CITY OF ALBUQUERQUE
DEPARTMENT OF MUNICIPAL DEVELOPMENT
ENGINEERING DIVISION

TITLE: CENTRAL–ATRISCO DRAINAGE IMPROVEMENTS PHASE III
GLENDALE ROAD
STA 10+00 TO 13+50

Project No.	Zone Map No.	Sheet	of
6749.04	K-11,J-11	3.1	14

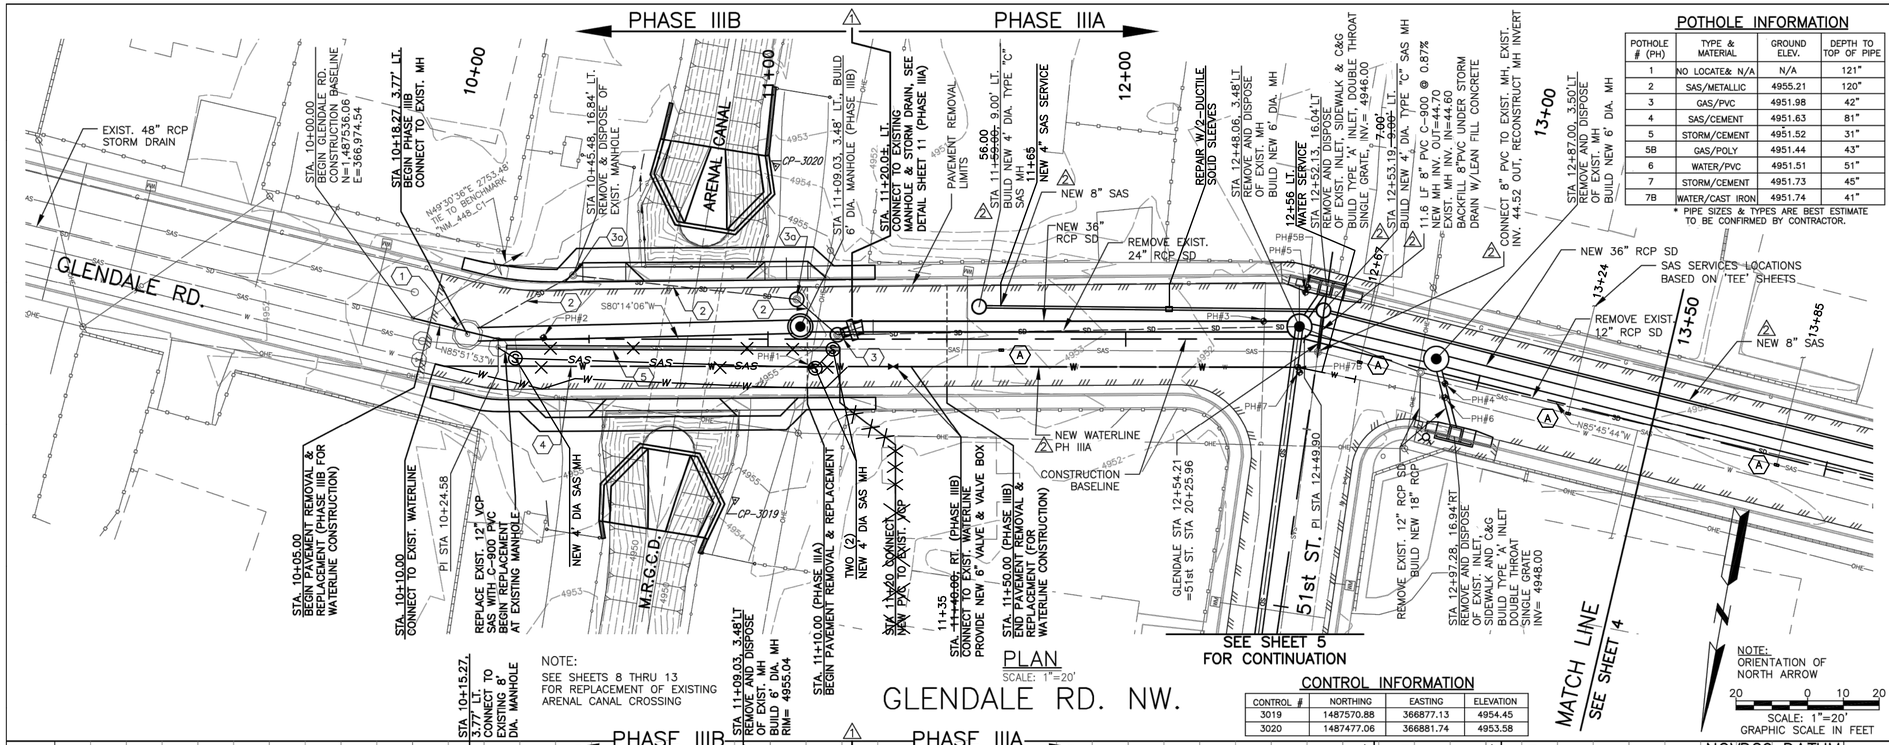
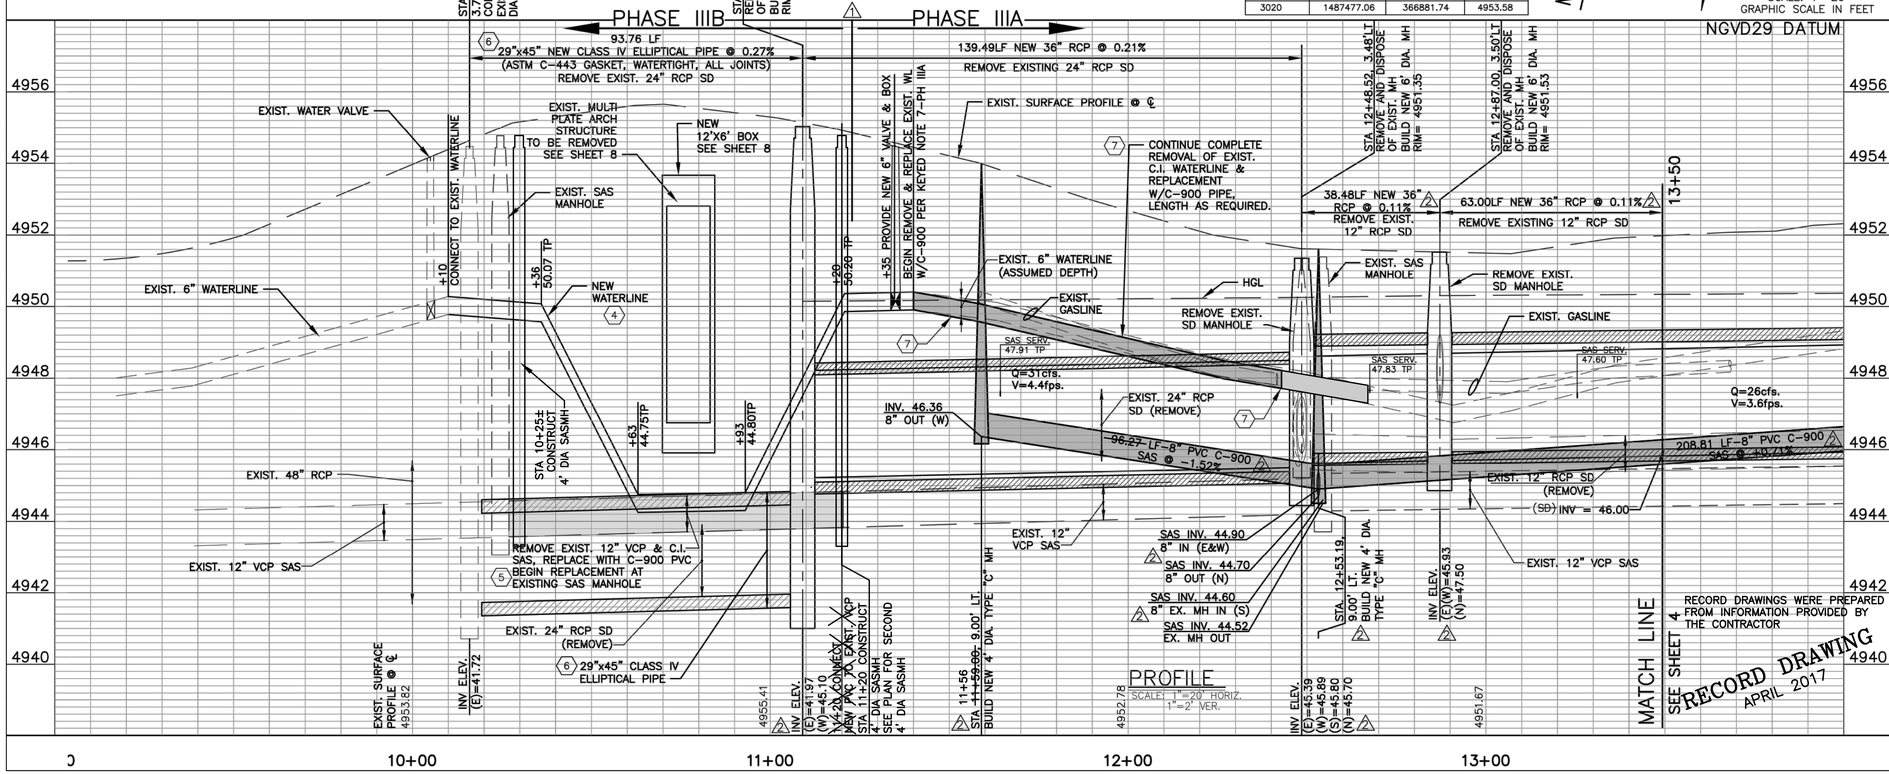
1. EXISTING 8' DIA MANHOLE
2. REMOVE AND DISPOSE 24" RCP–PHASE IIIB.
3. PHASE IIIA–CONNECT STORM DRAIN TO EXISTING MANHOLE, SEE DETAIL SHEET 11. PHASE IIIB–REMOVE MANHOLE & BEND AND EXTEND 36" RCP. SEE DETAIL, SHEET 11
3a. REMOVE AND DISPOSE OF EXIST. MANHOLE–PHASE ~~IIIB~~ 111A

4. REMOVE EXIST. 6" WATERLINE. INSTALL NEW 6" WATERLINE STA. 10+10 TO ~~STA. 11+40~~–PHASE IIIB STA 11+66
5. REMOVE SECTION OF 12" VCP & C.I. SANITARY SEWER AND REPLACE WITH 12" C-900 PVC–PHASE IIIB, SEE DETAILS ON SHEET 11.

6. PHASE IIIB–29"x45" REINFORCED CONCRETE ELLIPTICAL PIPE (RCEP) SHALL BE CLASS IV AND SHALL BE BEDDED IN ACCORDANCE WITH TYPE I INSTALLATION AS DESCRIBED BY AMERICAN CONCRETE PIPE ASSOCIATION AND BEDDED WITH CLASS I EMBEDMENT SOILS CLASSIFICATION MATERIALS PER SECTION 701 OF THE SPECIFICATIONS. CLASS I SOILS SHALL COMPLY WITH AGGREGATE BASE COURSE PER SECTION 302. ANY ADDED COSTS FOR FURNISHING AND INSTALLING SPECIAL BEDDING SHALL BE CONSIDERED INCIDENTAL TO FURNISHING AND INSTALLING THE RCEP. ~~USED UNDER CBC BOX ONLY~~

7. EXTEND WATERLINE REMOVAL & REPLACEMENT OF ALL CAST IRON PIPE–PHASE IIIA

(A) ABANDONED SAS SERVICE, CAPPED AT MAINLINE. NEW 4" SAS SERVICE, TAP AND LINE TO NEW 8" SAS.

NO.	DATE	REVISIONS	BY
4	06/30/16	REVISE SD, ADD SAS & EXTEND WATERLINE R&R	LARKIN
3	12/01/15	DIVIDE PROJECT, PH. IIIA & PH. IIIB	LARKIN
